Re: FCC ID: ACJ9TGCF-524

Applicant: Panasonic Corporation of North America

Correspondence Reference Number: 73535

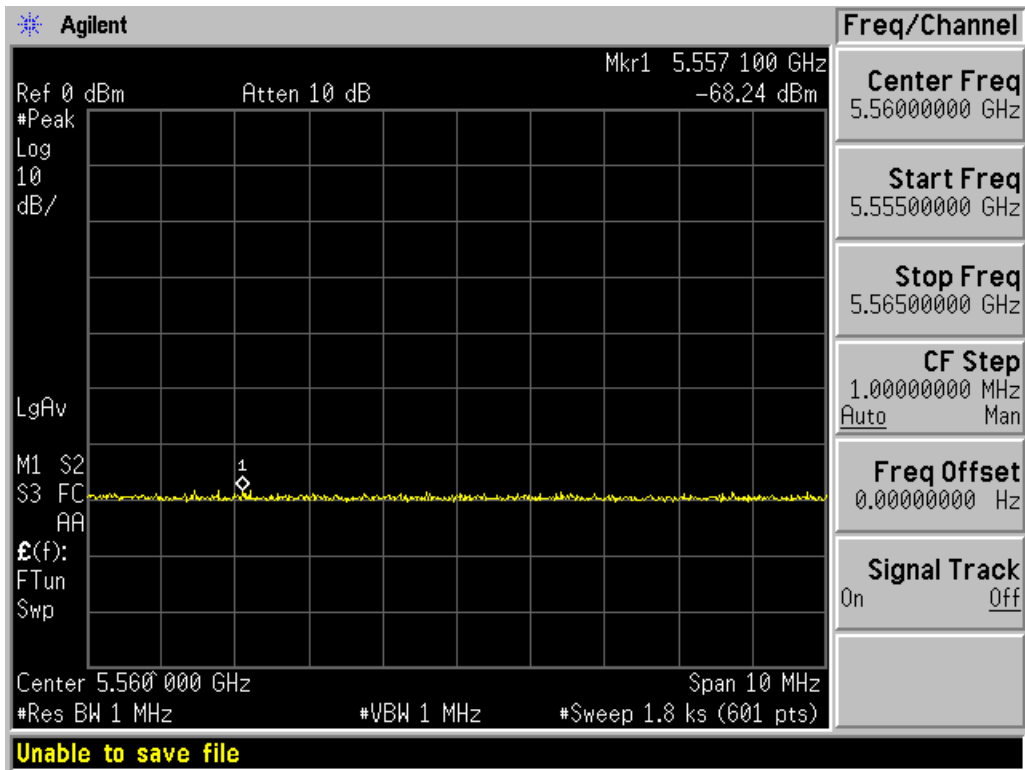
To avoid dismissal please submit a valid 30 minutes (1.8 KSec) sweep plot for the DFS non-occupancy test.

The original test report included plots for the non-occupancy period using a real-time spectrum analyzer however it does not indicate the actual 30 min monitoring time on the analyzer. The non-occupancy test was setup again and new plots were obtained using a spectrum analyzer with a 30 minute sweep time setting. Please see the new plots attached.
